ABERDEEN SCHOOL DISTRICT #5
Aberdeen School District Capital Projects 2026

410 North G Street
Aberdeen, WA 98520

INDEX TO ADDENDUM 1:

A ELEVATION
FS-1 SCALE: 1/2" = 1'-0"

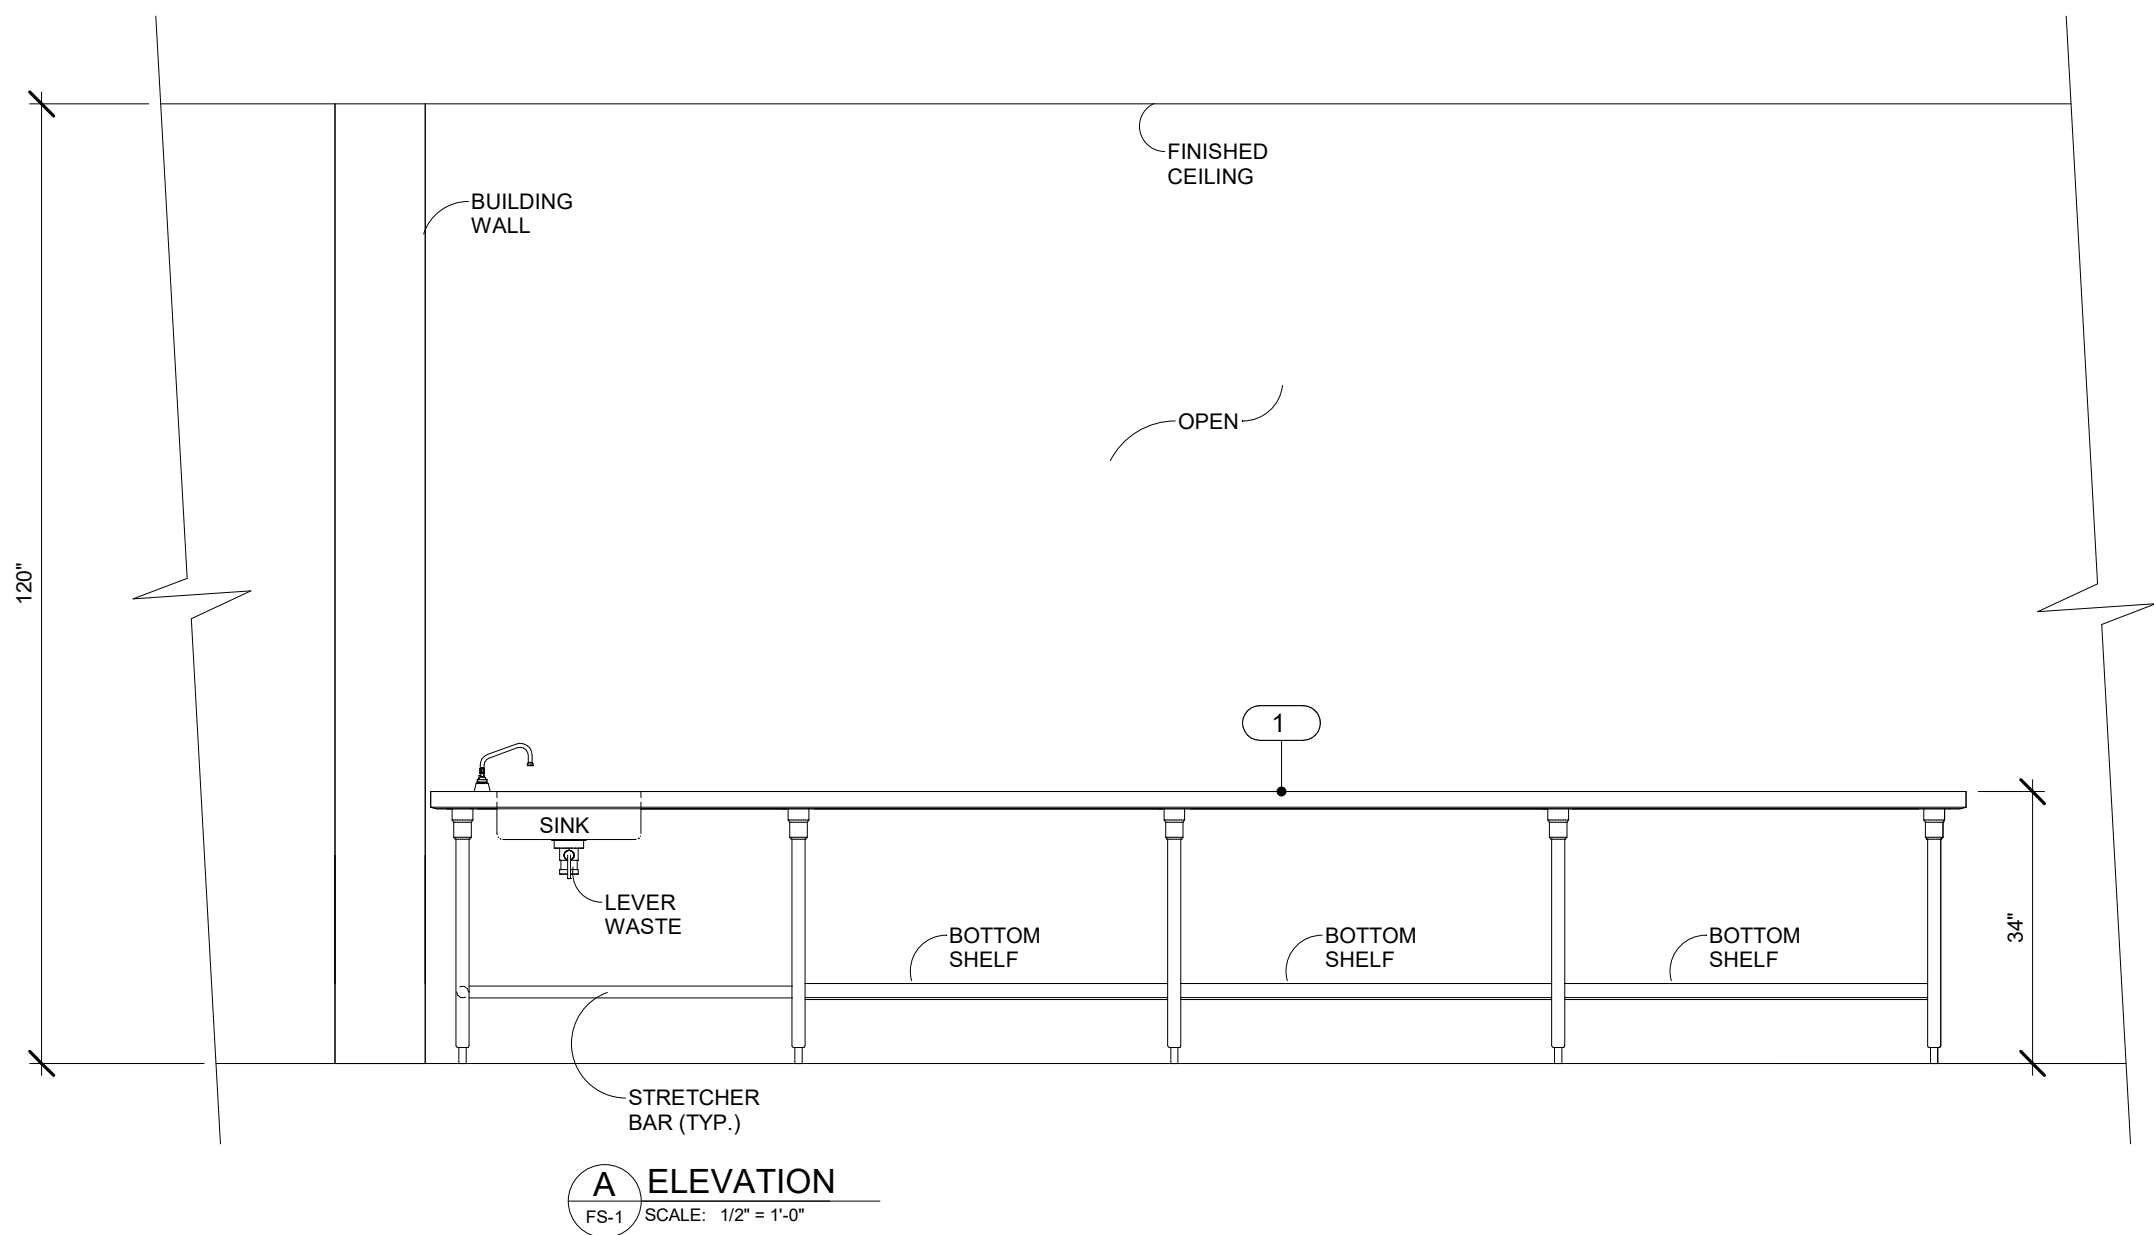
Answer: Refer to revised scope of work in specifications section 011000 included in Addendum 1 and revised drawings and specifications.
 - 5. **Question:** At Culinary Classroom, Is an in-direct drain required for the new sink? Is this a food processing sink?

Answer: Yes, in-direct will be required, see sheet FS-1.
 - 6. **Question:** At guardrail work, How is the fastener anchoring at the bottom holding?

9. **REPLACE** sheet **A72.10** in its entirety.
- B. Food Service Drawings
1. **REPLACE** sheet **FS-1 EQUIPMENT PLAN** in its entirety.
- C. Mechanical Drawings

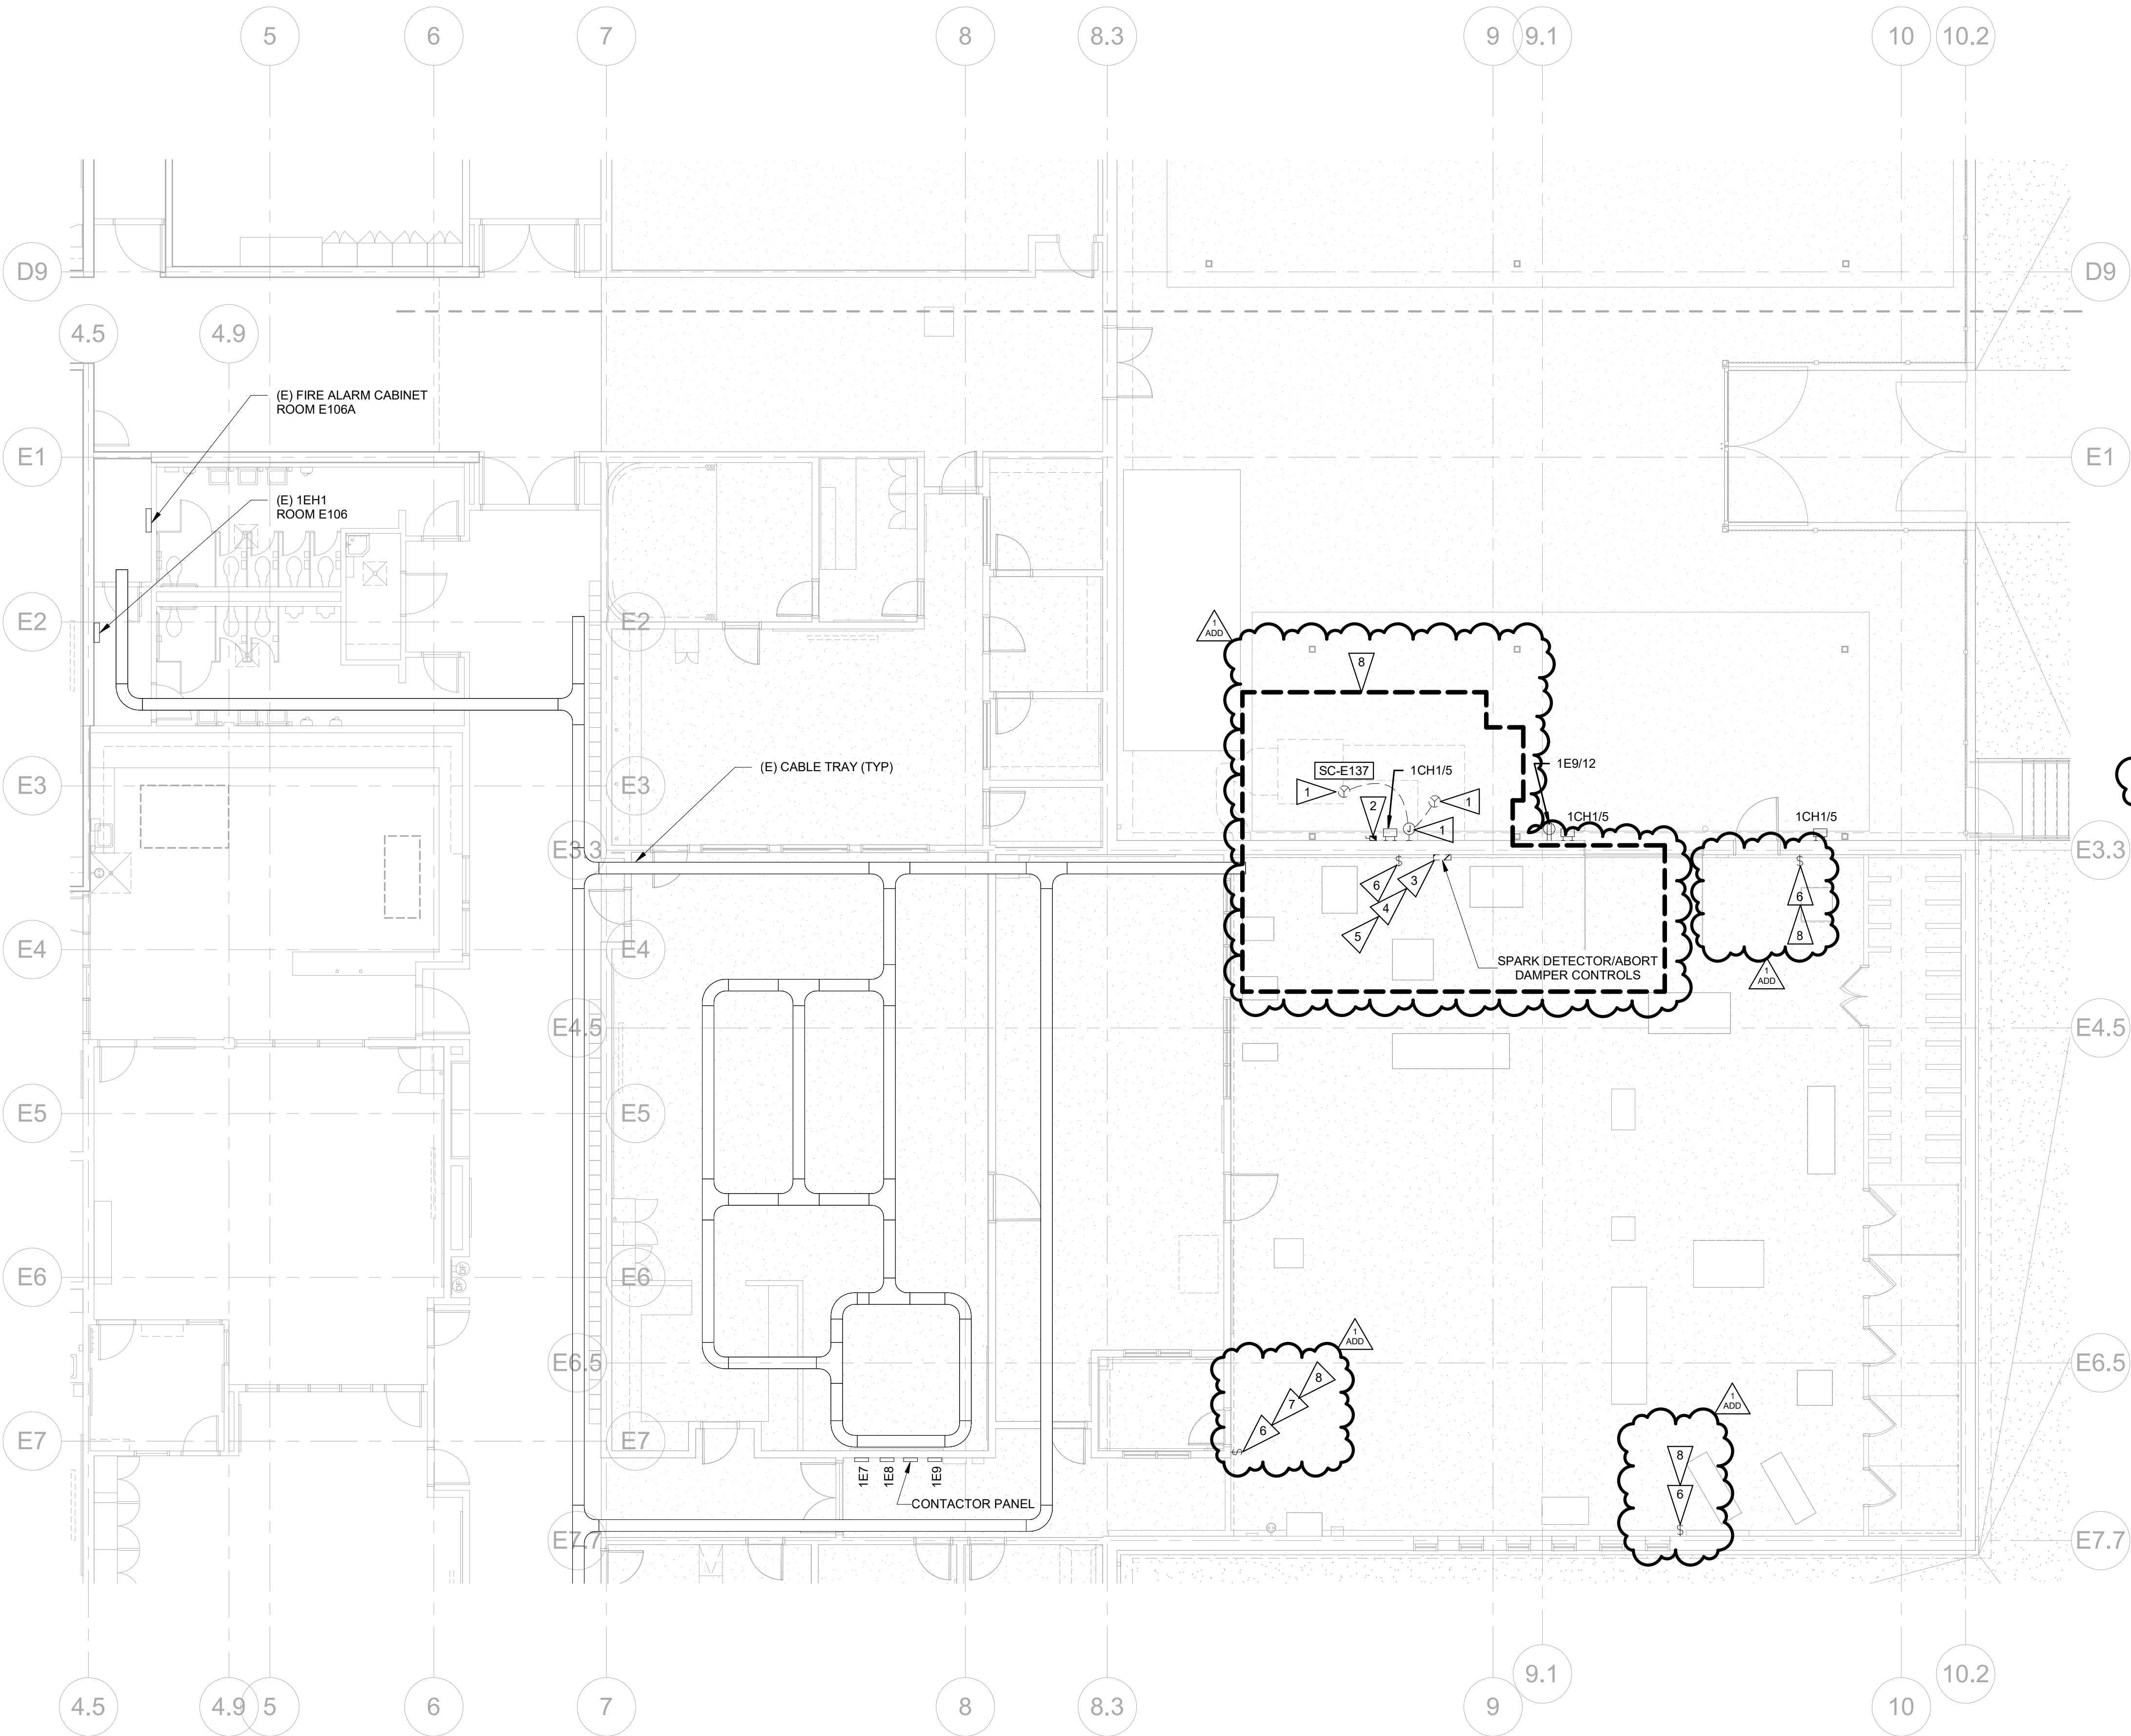
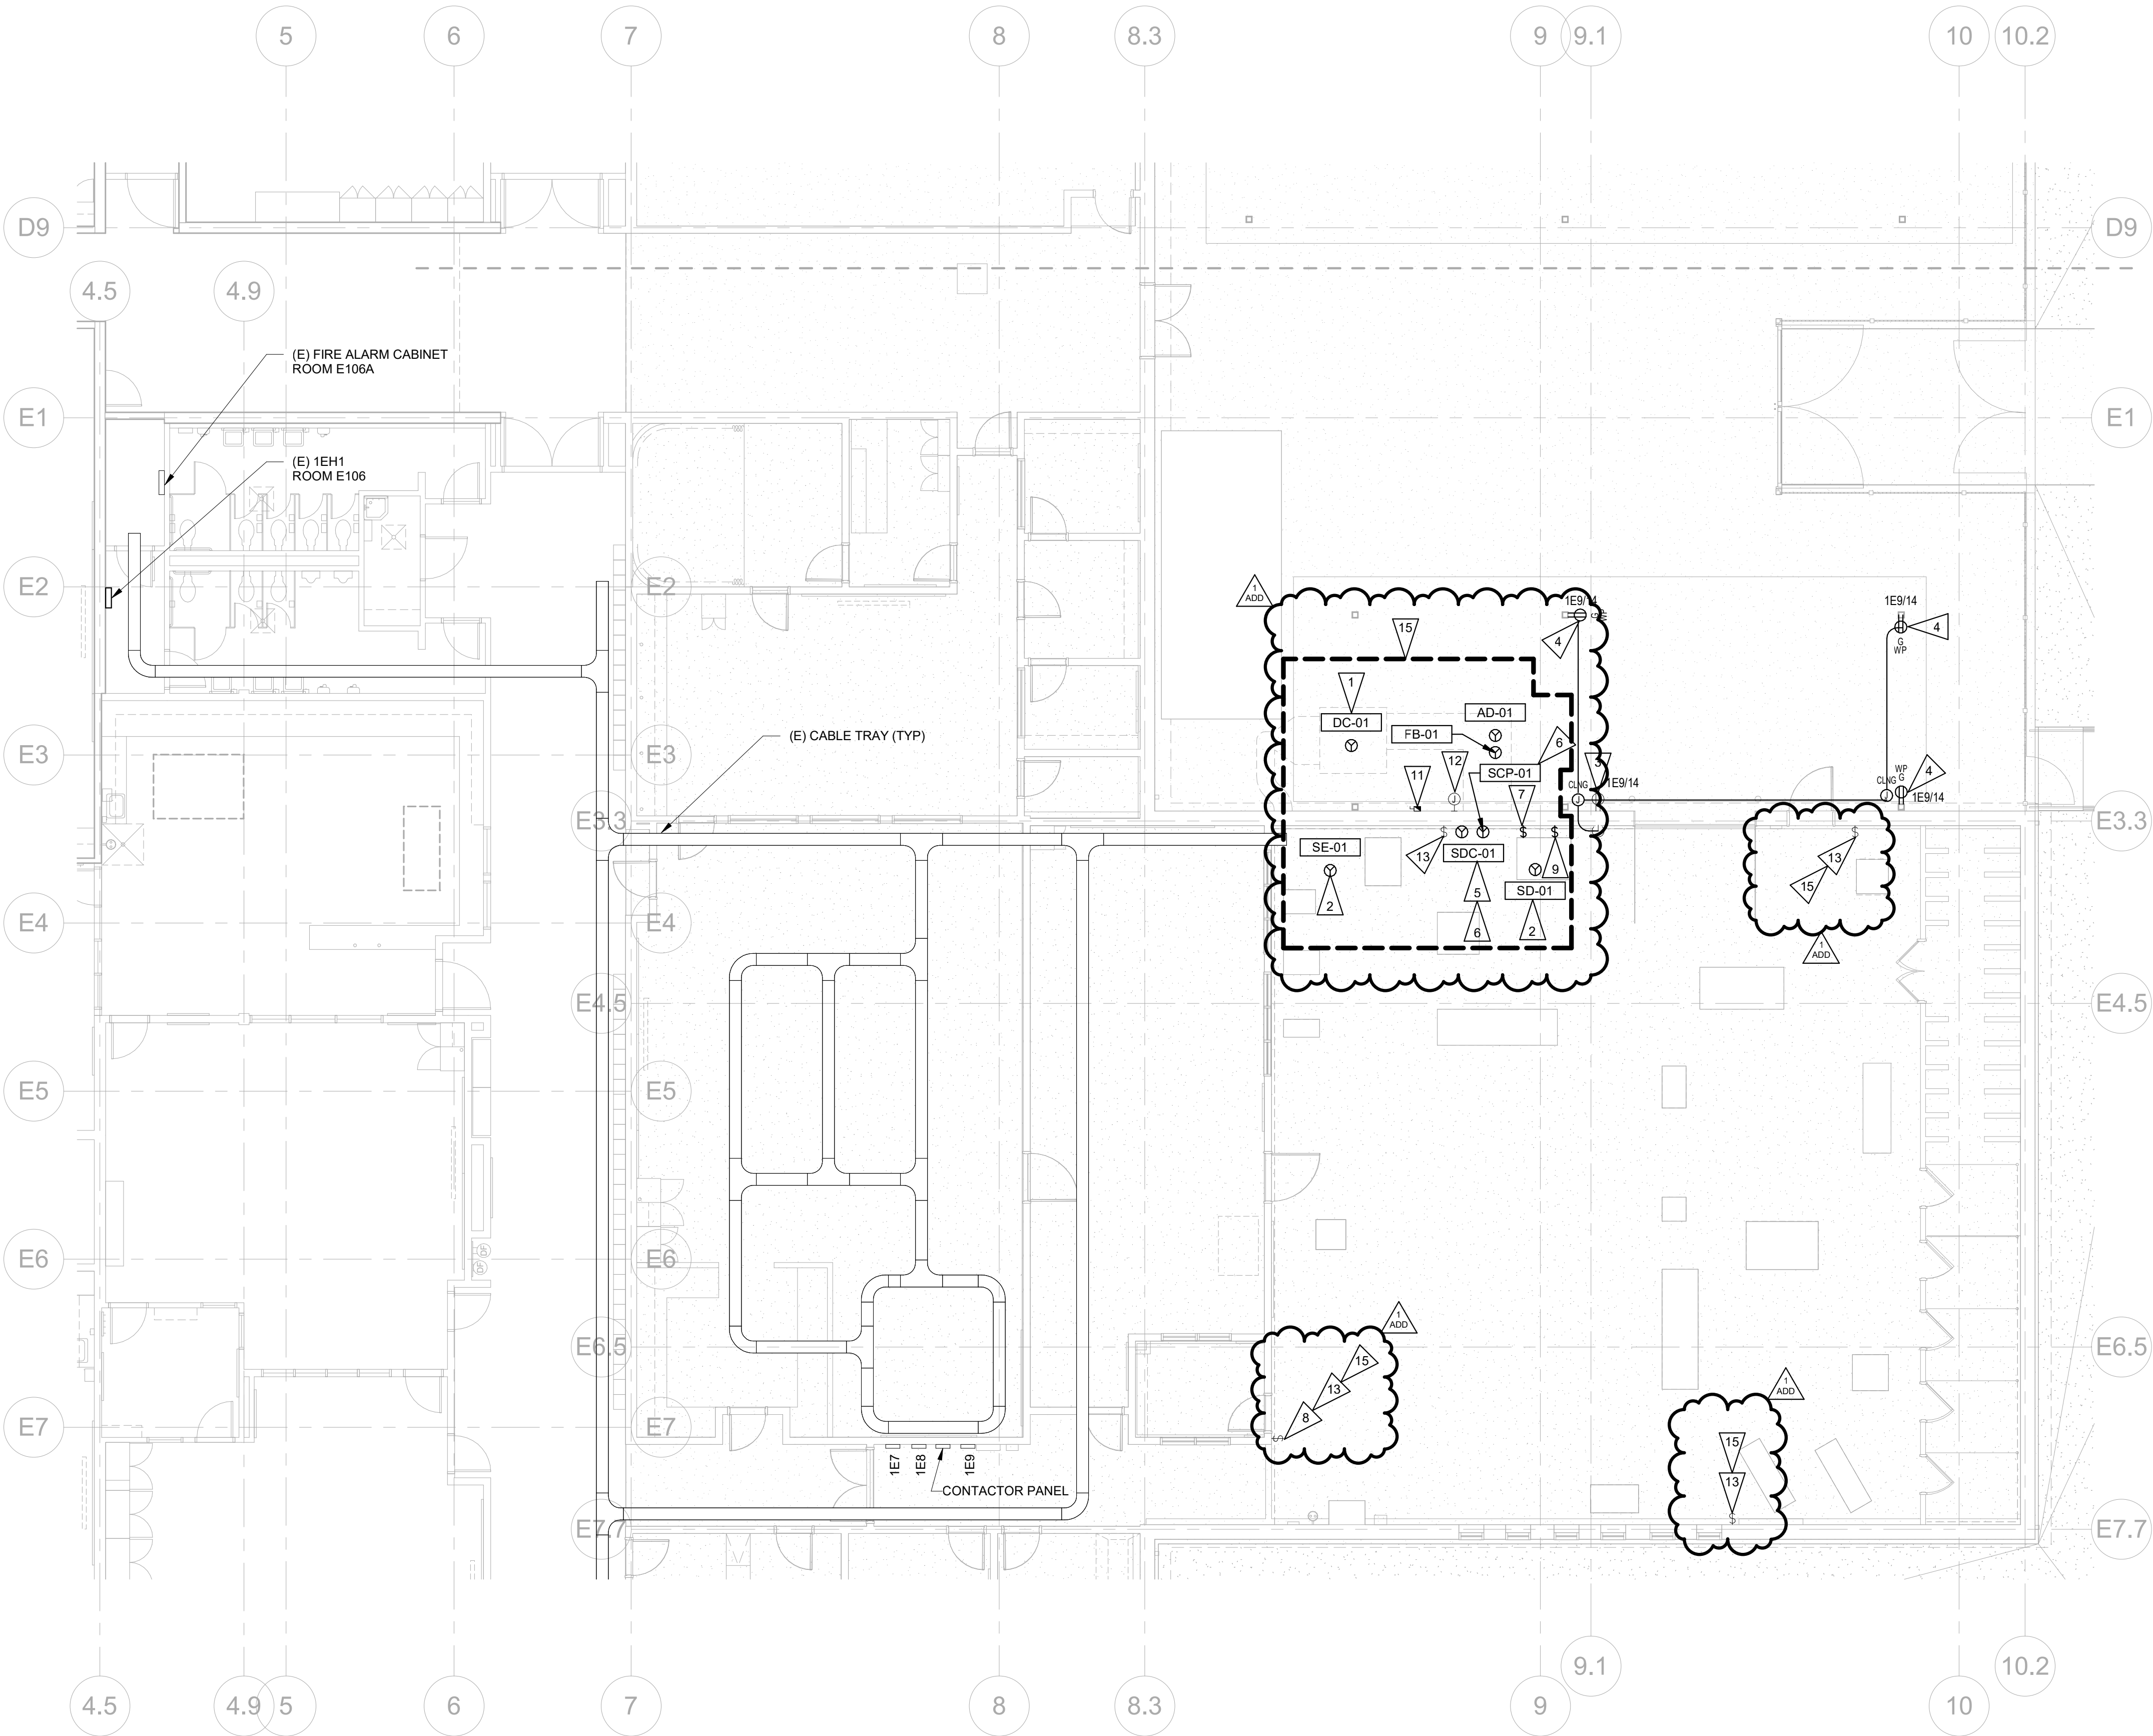
2. **REPLACE** Sheet **E0.04** in its entirety.
 3. **REPLACE** Sheet **ED3.11** in its entirety.
 4. **REPLACE** Sheet **E3.11** in its entirety.
 5. Sheet **E10.01**, **ADD** general note 1 to read "FOR INFORMATION ONLY - WORK UNDER SEPARATE CONCURRENT GENERAL CONTRACT."

- SEE SHEET E0.02 FOR ADDITIONAL GENERAL NOTES.
- REFER TO SCHEDULES ON SHEETS E0.03 FOR ADDITIONAL INFORMATION.
- DUST COLLECTOR WORK SHOWN FOR INFORMATION ONLY - WORK UNDER SEPARATE CONCURRENT GENERAL CONTRACT.
